\*\*\*\* IMPORTANT FIELD CORRECTIVE ACTION \*\*\*\*

Re: Volcano s5/s5i™ Family Software Version 3.2.1 / 3.2.2

## TWO POTENTIAL SOFTWARE ERRORS

#### INTERIM AVOIDANCE PENDING SOFTWARE PATCH

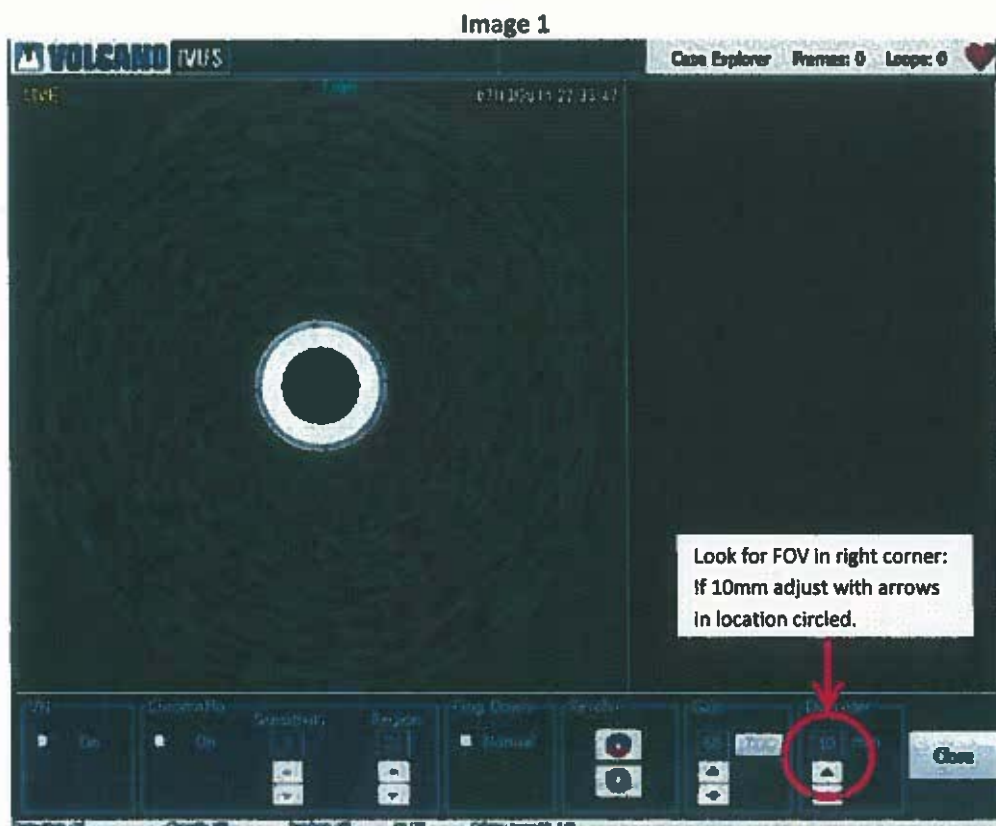
If you must change the FOV, follow these steps:

- Verify the FOV setting on the Adjust Image screen. (Refer to Image 1).
- If the system indicates 10mm, simply adjust using the up arrow or the down arrow to the desired FOV before recording.
- Confirm your measurements with those images acquired by angiography as directed by the Instructions for Use.

Image 2

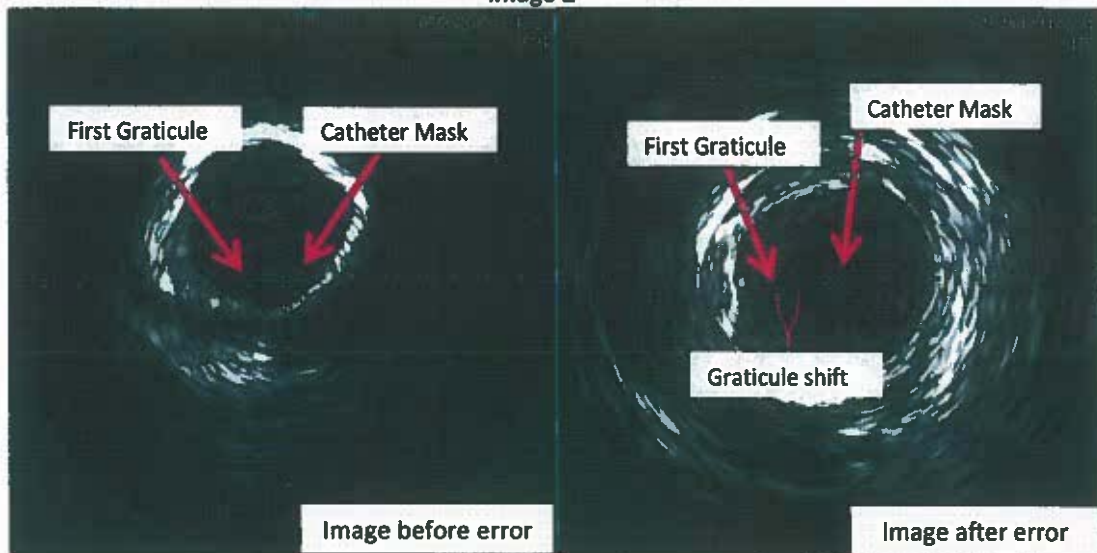
Pay attention to the following indicators as this error is easily detected by the following visual cues. Please refer to Image 2 which shows how easily the issue can be detected.

- The graticules shift from the defined FOV back to the normal (default) FOV.
- The first graticules from the center are not aligned with the edge of the catheter mask.

Once the errors have occurred any images captured in a Video Loop or Still Frame cannot be corrected. Affected Video Loops or Still frames can be detected by verifying whether the first graticules are aligned with the edge of the catheter mask (Refer to Image 2).

**Image 3**

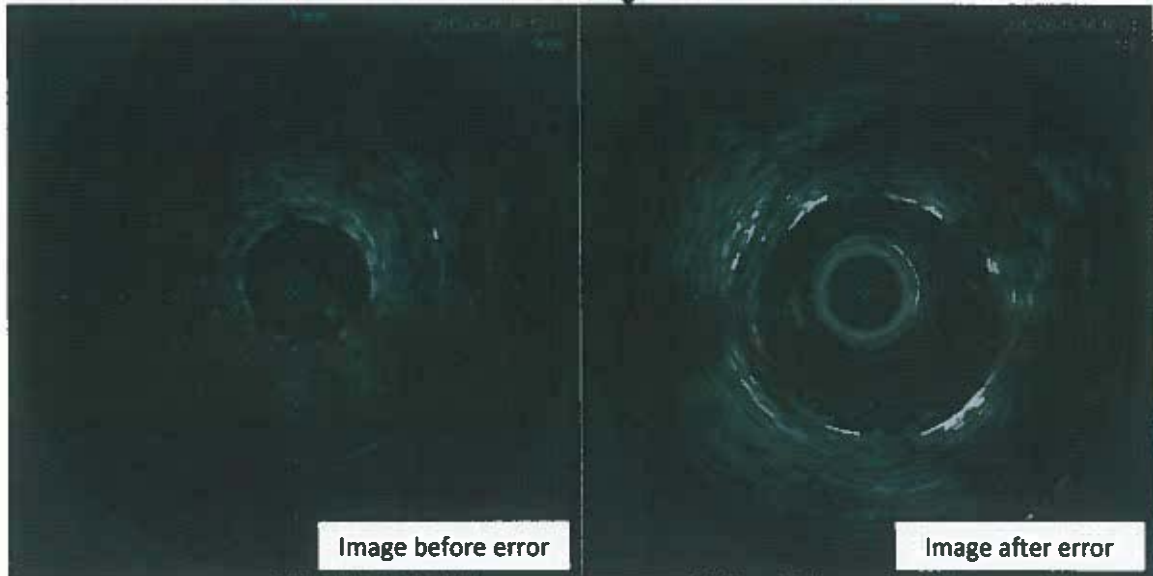
Pay attention to the following indicators as this error is easily detected by one or all of the following visual cues. Please refer to Image 3 which shows how the error can be detected.

- The quality of the image is significantly brighter from previous recordings and you will not be able to modify this image by adjusting the gain.
- The Catheter mask (center of the tomographic display) will increase in size by 1.5x and will have an unnatural appearance (i.e. no blood speckle).
- The image has a zoomed in appearance and becomes more obvious as the FOV increases beyond 10mm.
- The PIMr reset will cause the LED lights to turn off and on providing the users who work with the PIMr a visual cue that the PIMr is resetting.

The images below were taken at the same point in the vessel; the correct image identified as "Image before error" is displayed on the left and the incorrect image identified as "Image after the error" is displayed on the right.

Once the errors have occurred any images captured in a Video Loop or Still Frame cannot be corrected. Affected Video Loops or Still frames can be detected by verifying whether the presence of a white ring as shown in the right hand picture of Image 3.

If you must change the FOV and you believe an error has occurred (see section below for detection of the error) then disconnect the PIMr, reconnect it and re-image. Per normal practice, confirm your measurements with those images acquired by angiography as directed by the Instructions for Use.
